AMERICA'S CUP CLASS

CONFIDENTIAL INTERPRETATION No 2

June 07, 2005

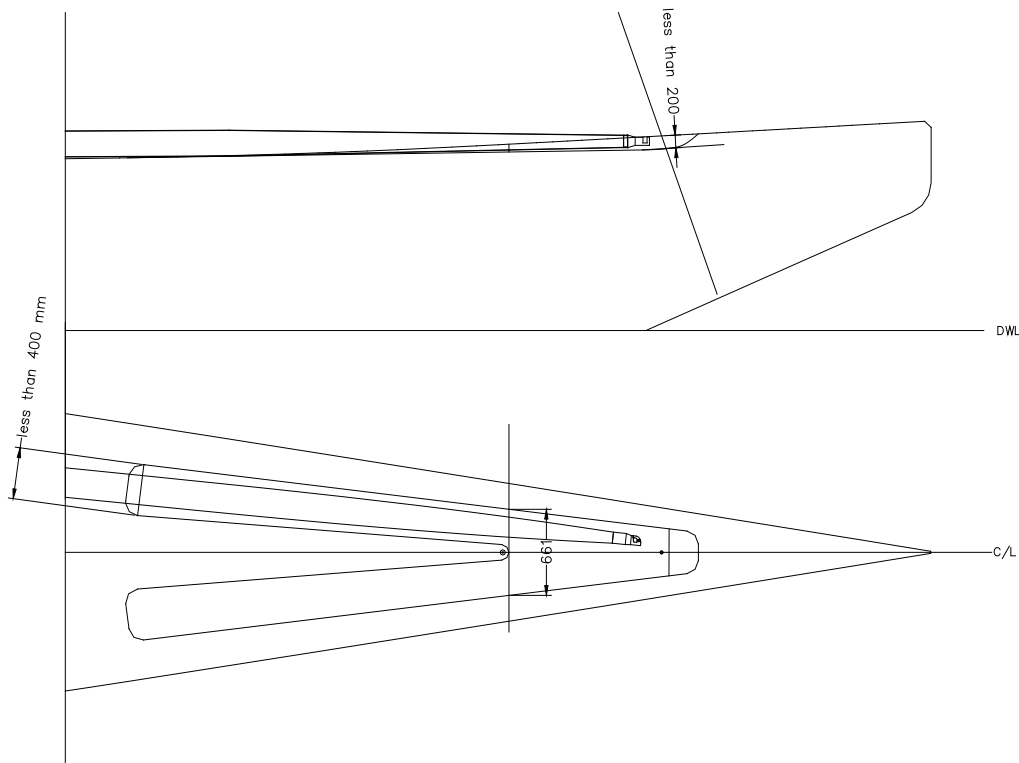
Please confirm if the spinnaker pole trough in the diagram below conforms to ACC Rule 18.3(a), having regard to ACC Public Interpretation No 2

The trough is shallower than 200mm, it is less than 800 mm wide from the edge of the adjacent edge. It is wider than 800 mm from the outside edge to the opposite edge (non adjacent).

The arrangement shown in the provided sketch shows two troughs connected by a common forward section. Rule 18.3 permits one trough to accommodate the spinnaker pole. Accordingly the arrangement shown is not permitted. END
